UNITED STATES PATENT AND TRADEMARK OFFICE

APPLICATION NO.	FILING DATE	FIRST NAMED INVENTOR	ATTORNEY DOCKET NO.	CONFIRMATION NO.
10/800,867	03/16/2004	Masayuki Takenaka	118363	1563

Office Action Summary	Application No. 10/800,867	Applicant(s) TAKENAKA ET AL.	
	Examiner Nguyen N. Hanh	Art Unit 2834

DETAILED ACTION

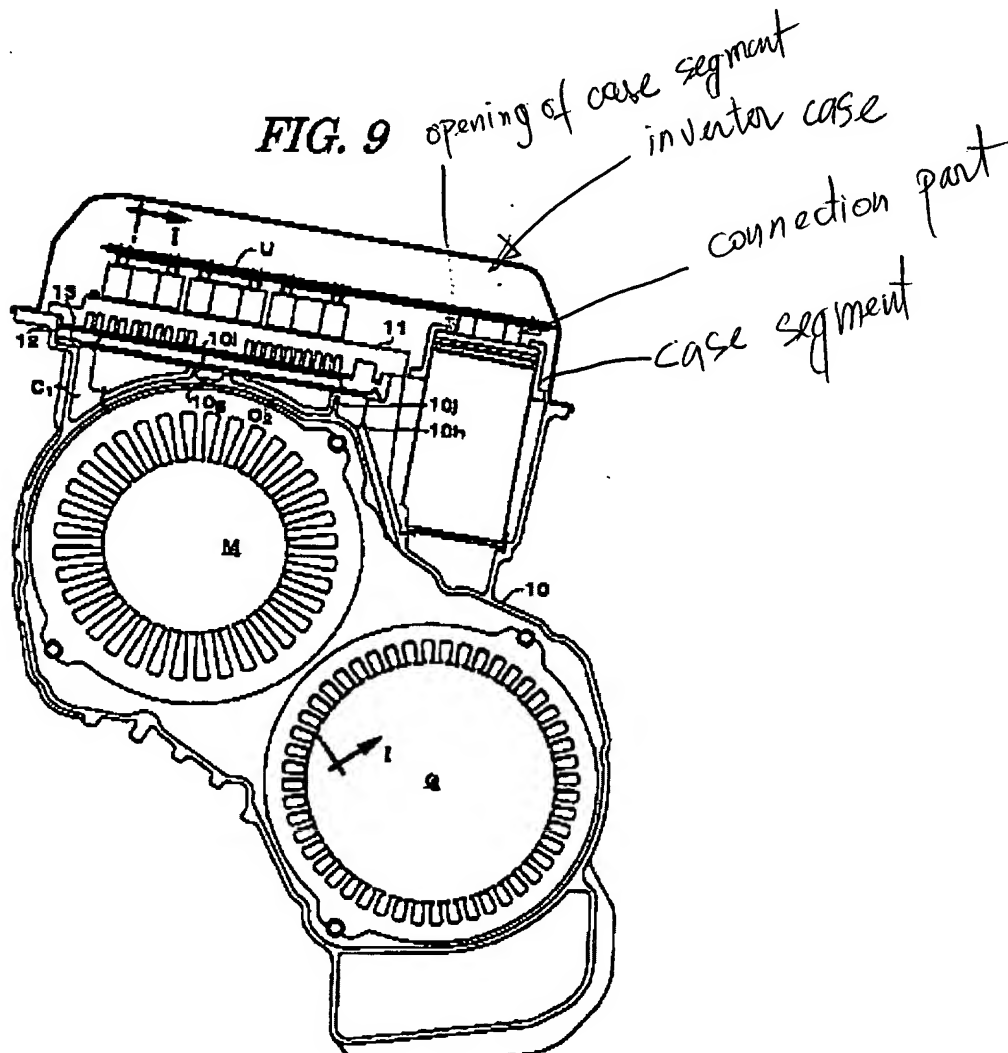
Regarding claims 15, 19 and 20, Hara et al. disclose a drive system wherein the electric power devices are connected to the respective inverters with connection parts (please see markups below) which extend out from the corresponding case segments.

Regarding claims 21 and 16, Hara et al. disclose a drive system wherein each of the connection parts has a terminal which extends through the corresponding case segment and which projects into the inverter case (Fig. 9).

Regarding claims 17 and 22, Hara et al. disclose a drive system wherein each of the terminals is positioned near an opening of the corresponding case segment.

Regarding claim 25, Hara et al. disclose a drive system wherein the mating surface between one of the case segments and the common inverter case is a substantially rectangular frame with round corners (Fig. 7).
